**Re: Falcon Cove Beach Water District (PWS #00045) – New Well L132105  
Curran-McLeod Project # 1530  
Conditional Approval (PR #77-2019). SRF SD# 19-242**

**The project is approved provided the following conditions are met:**

The project includes drilling a new well to serve the District as shown below.

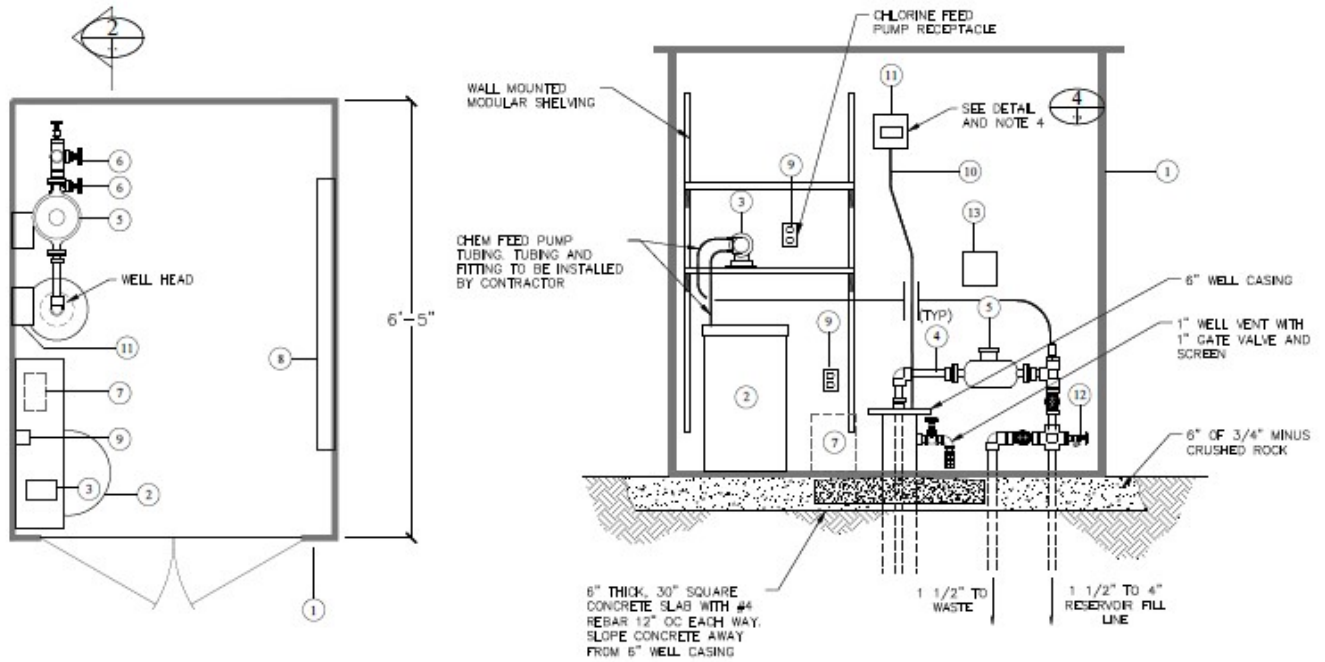
- 2) Information that demonstrates how the water system meets OAR 333-061-0050(5)(e): “Provisions shall be made to alert the water supplier before the chlorine supply is exhausted.” This requirement can be satisfied by either installing a low-level chlorine alarm or by creating a written procedure to check the chlorine tank daily.

- 3) A raw water sample tap (prior to chlorine injection) is installed (both raw and treated water sample taps are needed);
- 4) The chlorine product being used demonstrates it meets NSF Standard 60;
